<b>SERVICE</b> 		<b>1</b>
		<b>B9800068</b>

## SB, 365, 371, Clutch drums, 1998-12

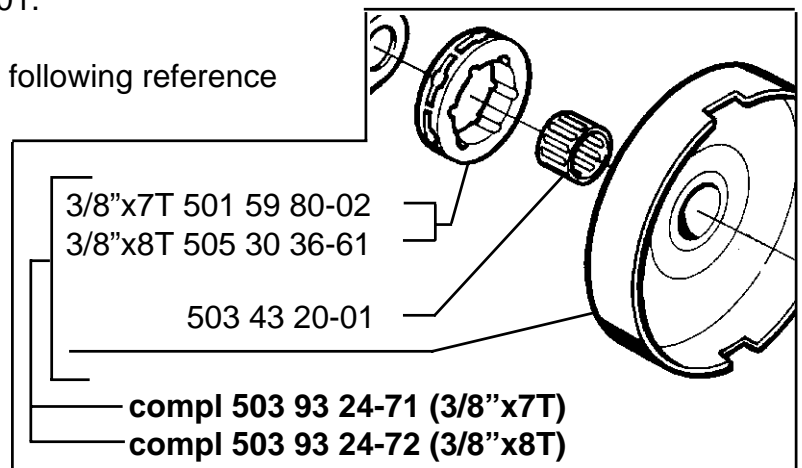
Clutch drums **without** ventilation holes have been introduced on the following variants:

365      •13   •14   •15   •17

With effect from serial number 8430001.

371      •01   •04   •05   •06   •08   •11   •12

With effect from serial number 8420001.

Clutch drums **without** holes have the following reference numbers:

- assy. 503 93 24-71 (3/8"x7T)
- assy. 503 93 24-72 (3/8"x8T)
